## Cultural Heritage Subcommittee (CHSC)

Meeting Date: September 13, 2023

**SUBJECT:** **Cultural Heritage Permit 22-148, Architectural Permit 22-162, Nielsen Residence**, a request to consider: 1) an addition and exterior changes to a historic single-story residence, 2) construction of a detached garage with an Accessory Dwelling Unit on the second floor that requires a height limit increase, and 3) changes to the garden landscape and hardscape. The site is located at 222 West Mariposa.

**Image 2 – Excerpt of Proposed Roof Plan**

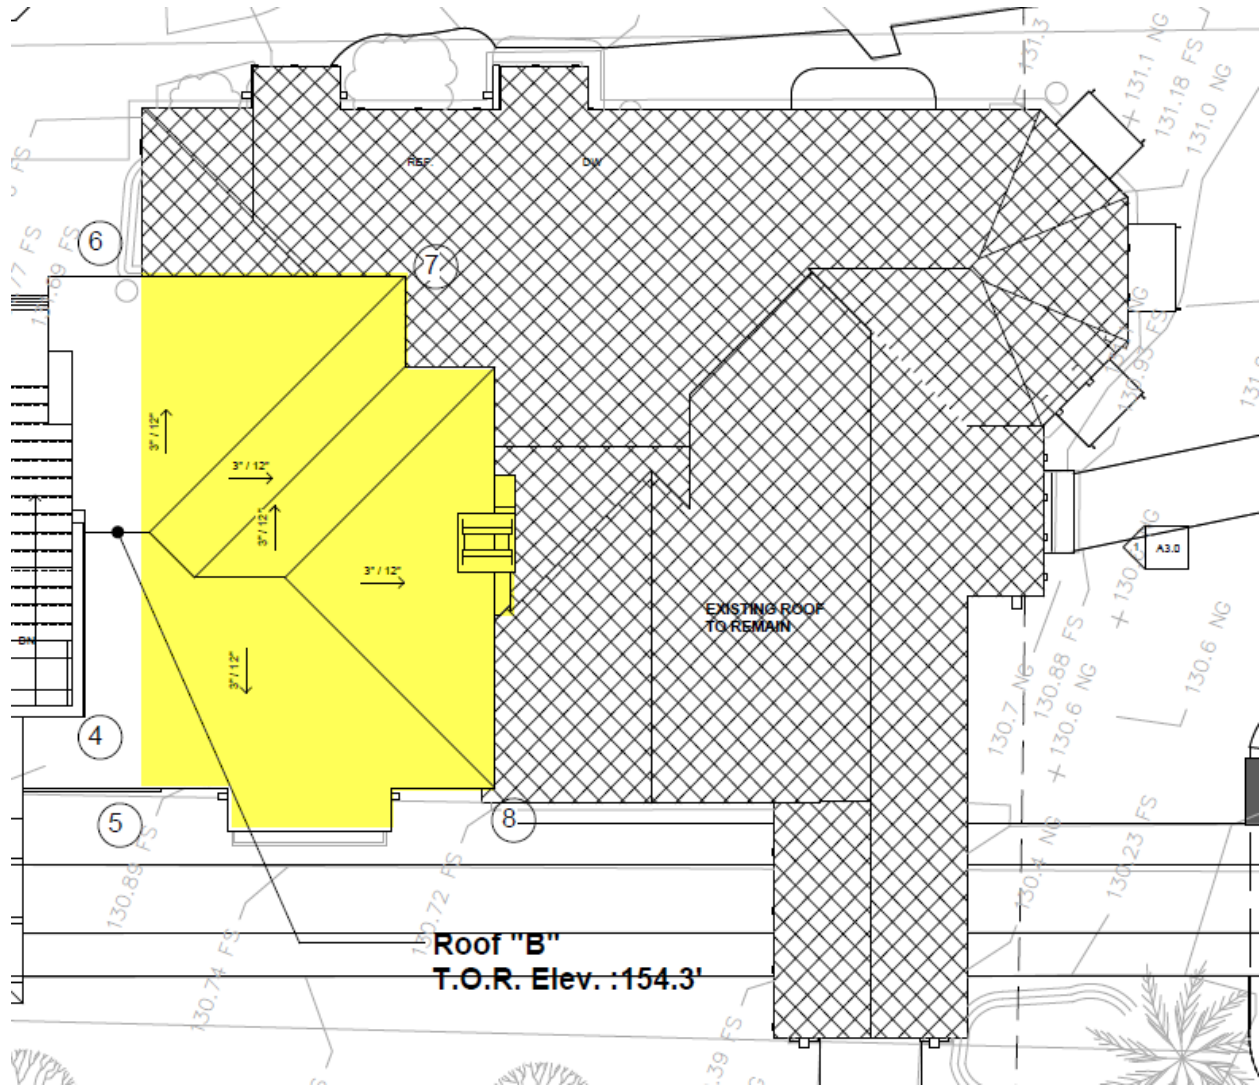
The project adds a 648 square-foot second story over the original structure with the removal of the original roofline and area. Image 1 shows the west elevation where the second-floor addition is proposed. The original roof between the red and orange lines would be removed. Excerpts of the proposed roof plan and west elevation are on the next page.

The original roof area that would be removed for the second-floor addition is highlighted yellow.

<b>Prior Recommendation</b>	<b>Applicant Response</b>
1. Redesign and relocate the second-floor addition, so it is not over the original first-story massing of the historic residence.	The second-floor is redesigned so it is no longer over the original first-story building footprint and roofline. A built-up shed roof is proposed over a portion of the original roof at the rear, for water drainage and protection. The built-up roof preserves the original framing members and roofline so it is reversible consistent with Secretary of the Interior Standards. The revised and prior plans are attached to allow for a comparison.

**Image 5 – Proposed first-floor excerpt**  
(grey = proposed addition)

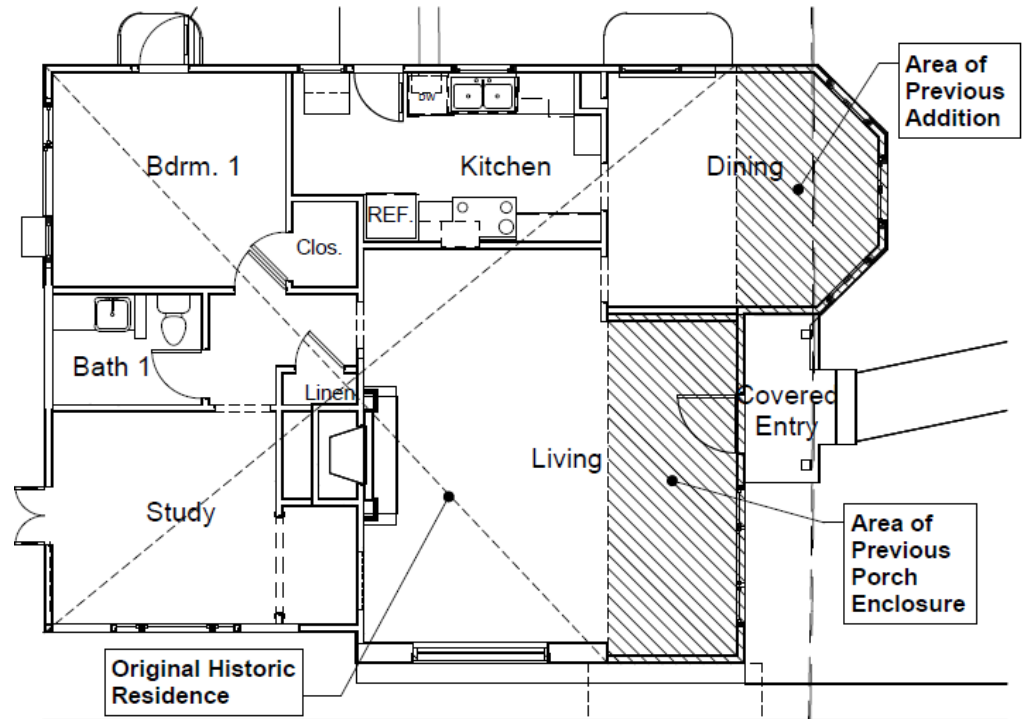
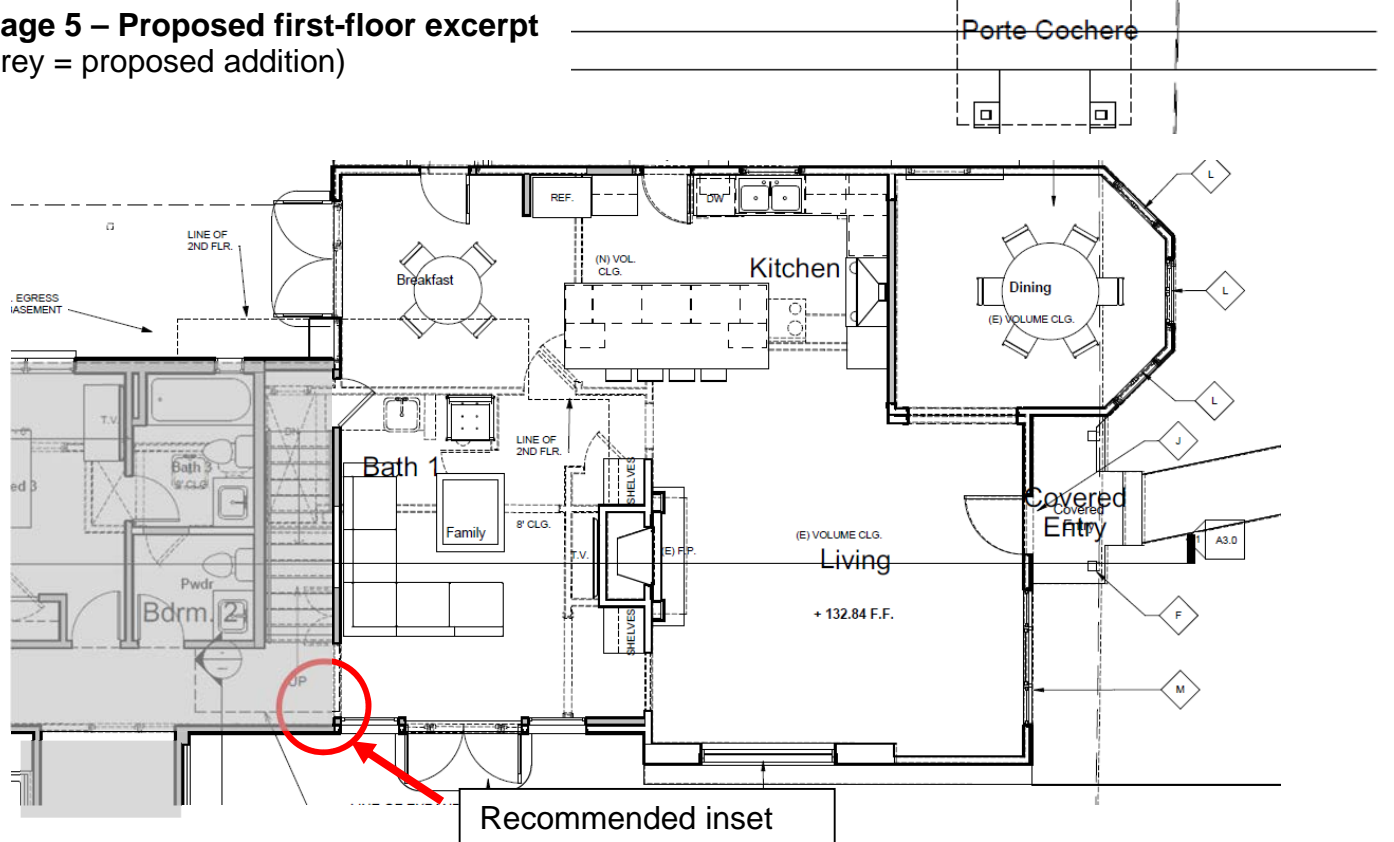
Secretary of the Interior Standard 10 calls for differentiating additions and alterations from original significant elements of a resource. The current design expands the building in-line with the original first floor. Staff recommends varied texture and color, and a spatial break 1-2 inch inset between the original structure and addition to differentiate the addition, consistent with Secretary of Interior standard nine (cited on page above).

2. First-floor addition should be differentiated from original structure with insets.	The first story addition is revised to have an inset from the original first-story elevation as recommended.

**Image 6 – Excerpt of Proposed Landscape Plan** (red arrows show the tree significant trees along street)

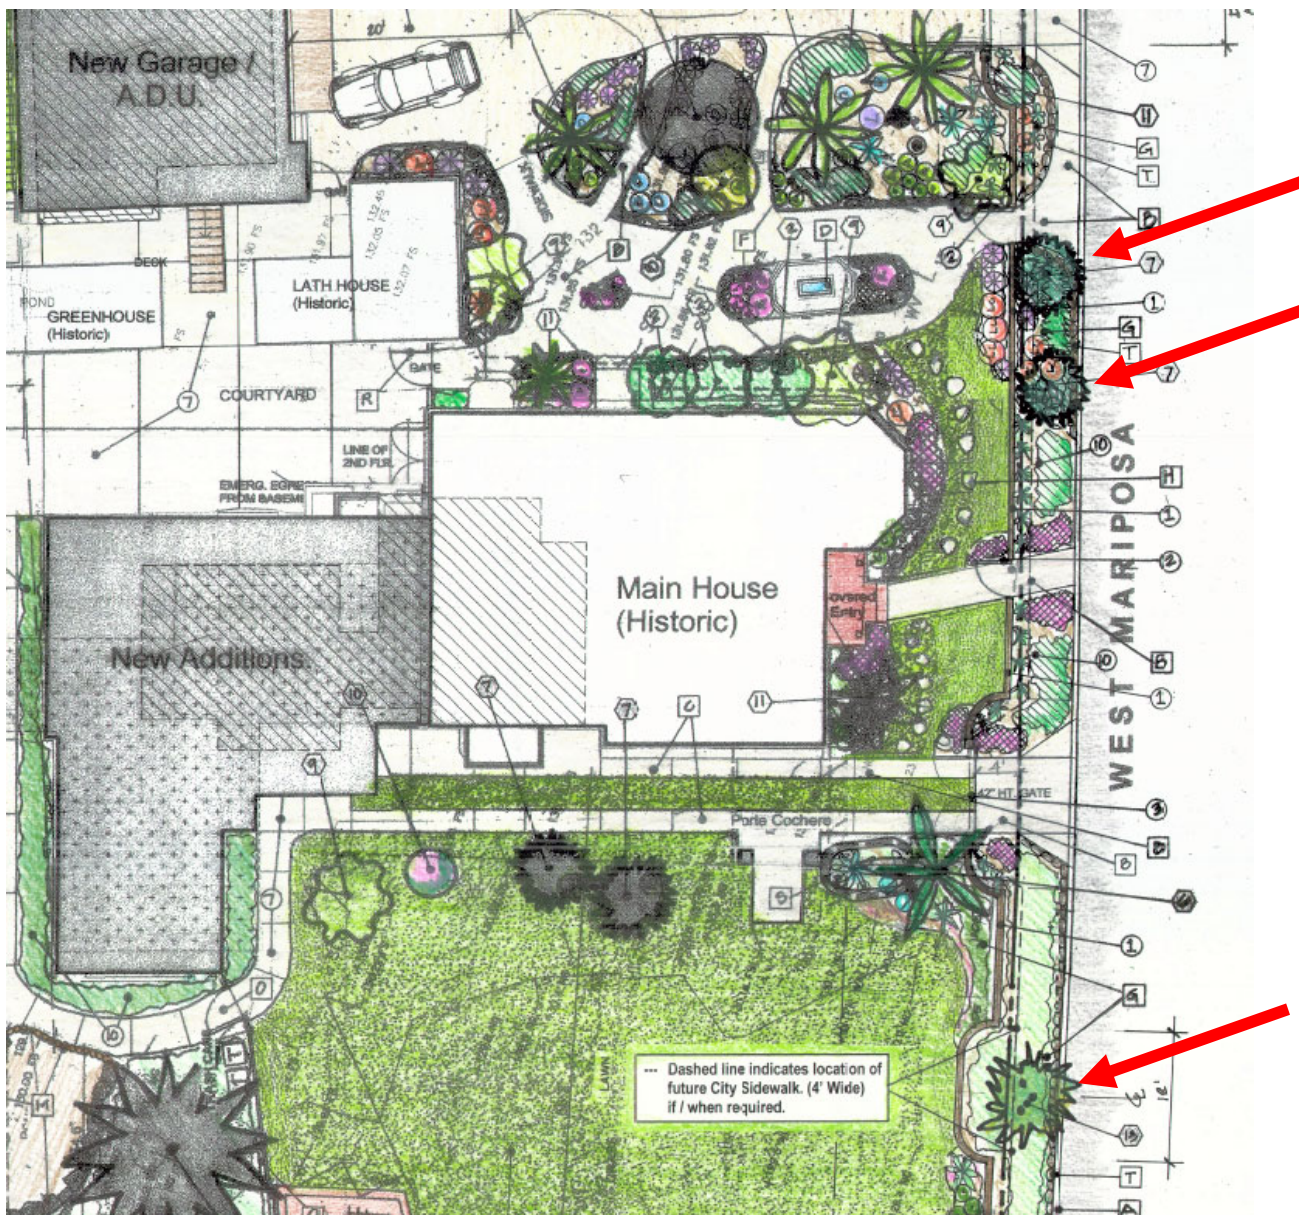
The Municipal Code requires the installation of sidewalk for development projects valued at \$50,000 or more, including the proposed project. However, the site is unique in two ways. First, the Casa Romantica and the subject site are the only known historic resources with historically significant gardens. Second, the subject site is the only known property on the City's listed of designated historic structures with historically significant trees in close proximity to a street frontage that would interfere with the installation of the sidewalk. There are three trees near the street that are character-defining features to the property's significant garden: a Yucca and two Japanese White Pines ("bonsai trees"). Image 6 shows the location of these trees.

Ideally, these trees would be preserved to maintain the integrity of the resource. While the City has a sidewalk waiver process, the eligibility criteria does not address waiving a sidewalk to preserve historically significant trees and garden features. The application initially had a design that kept the historically significant trees along the street without a sidewalk installation. During the Development Management Team (DMT) process, the City staff considered several options for the sidewalk:

Staff supports option 1 to defer the sidewalk and add a condition on the Historic Preservation Property Agreement (HPPA) that requires installation of a sidewalk upon the death of the historic trees. The Community Development Director may add conditions to the HPPA but staff would seek guidance from the Planning Commission when it acts on the project. Staff requests CHSC feedback on this important issue so the applicant has information to decide how to proceed.

3. Removal of significant trees for a required sidewalk.	The landscape plan shows the significant trees would be preserved and sidewalk construction deferred until the natural death of the trees. The replacement trees would be a similar type and vicinity as the existing trees. This requirement would be incorporated into the Mills Act Agreement.
